PLANNING COMMISSION REPORT
Regular Agenda – Public Hearing Item:

PC Staff Report
03/24/14

ITEM NO. 1: SPECIAL USE PERMIT FOR A PUMP STATION; 547 MAPLE STREET (SLD)

SUP-14-00007: Consider a Special Use Permit for a Pump Station, located at 547 Maple & 500 Perry St. Submitted by Bartlett & West, for the City of Lawrence, property owner of record.

Figure 1: Proposed Site Plan

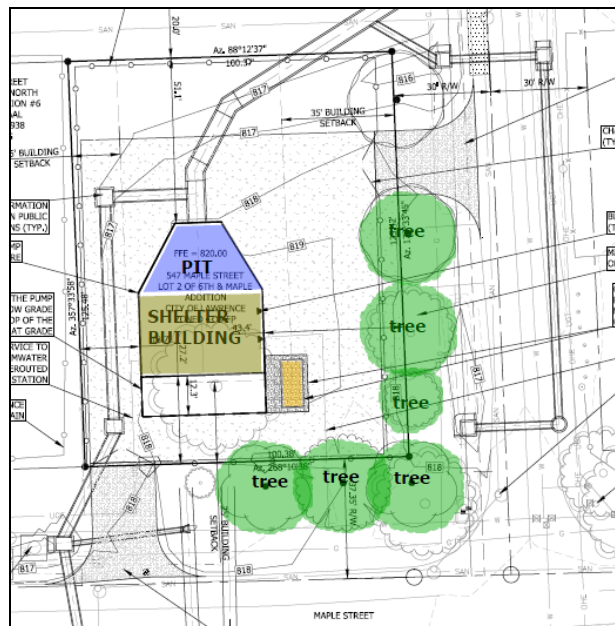
Additional details regarding the site lighting are required. The applicant intends to use building mounted lighting for this site. All lighting fixtures will need to be directed down and be provided with a full cut-off. Staff recommends that, as a condition of approval, prior to the issuance of a building permit, lighting fixture details be provided for staff review and approval.

The generator pad site is located approximately 30' from N. 6th Street. The generator is an accessory structure in this application. The development code states that accessory equipment shall be located in the rear portion of the property. The Development Code provide the authority for the Planning Director waive certain development standards per section 20-1305 (b)(3)(v).

The location and orientation of the facility design is determined by the existing infrastructure. The placement of the generator on the north (rear) side would interfere with the operation and maintenance of the site.

1. Applicant shall provide a revised site plan with the following changes:
 1. Provide a note on the plan that states lighting fixtures shall be provided with a full cut-off fixture and be directed down. Applicant shall provide lighting fixture details for review and approval prior to issuance of a building permit.
2. Submission of final building elevations for review and approval prior to issuance of a building permit.
3. Approval of the Special Use Permit is contingent upon approval of a Floodplain Development Permit. The SUP will be released to Development Services for a building permit after a Floodplain Development Permit application has been approved.

Figure 2: recommended landscape

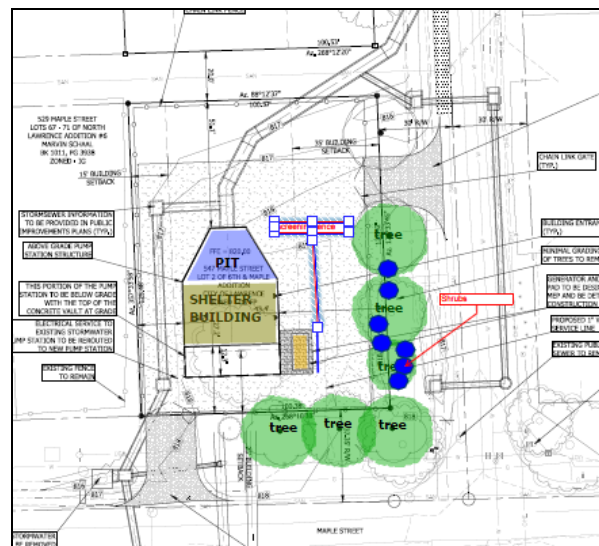
Screening for the generator must balance the ability to access the equipment for fueling as needed and provide security to the site by being readily visible from the public streets with the need for visual screening/buffering from the street right-of-way and adjacent residence to the east. It may be possible to add shrubs along the fence line along Maple Street and 6th Street to provide some screening of the generator. The following graphic shows the addition of a fence along with shrubs to provide screening. The plan proposes a 6' high chain link fence along the perimeter in addition to safety fencing around the pit area at the interior of the site. Staff recommends decorative fencing be provided along the public right-of-way along N. 6th Street and along Maple Street. This is consistent with industrial design guidelines that would be applicable to similar private development applications.
